Re: Ordinance 79-17 – Rezoning 25 parcels from BSD Historic Core District to BSD Historic South District (Case 17-074Z - Historic Dublin Zoning Rezoning).

AN ORDINANCE REZONING 25 PARCELS TOTALING APPROXIMATELY 5.04 ACRES FROM BSD-HC, BRIDGE STREET HISTORIC CORE DISTRICT TO BSD-HS, BRIDGE STREET HISTORIC SOUTH DISTRICT (CASE 17-074Z).

HISTORIC DUBLIN: **EXISTING ZONING CODE**

SUMMARY & EXPLANATION OF PROPOSED REVISIONS

Illustration of the scale of development proposed in the code revisions for the rear of the Historic Cottage Commercial Building Types.

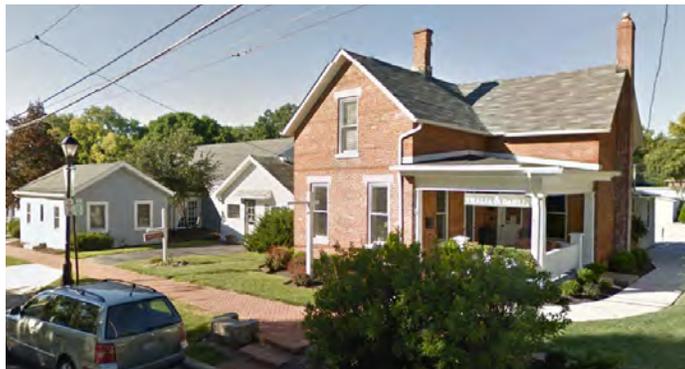
Ms. De Rosa suggested that it would be more helpful to really show that the character is actually going to be maintained by these standards. She said the drawings do not currently depict what she is hearing staff articulate or what she has read in the Code. In fact, she said, just the opposite because it appears dense and out of character as they are not demonstrating a cottage feel.

The axonometric renderings used to illustrate the various zoning standards are being simplified to better communicate the intent of the regulations. In addition, to clarify any confusion regarding the applicability of parking requirements, Staff has asked the consultant to prepare new illustrations that depict development types (e.g. retail, office, residential) as they would meet lot coverage, setback, open space, and parking requirements.
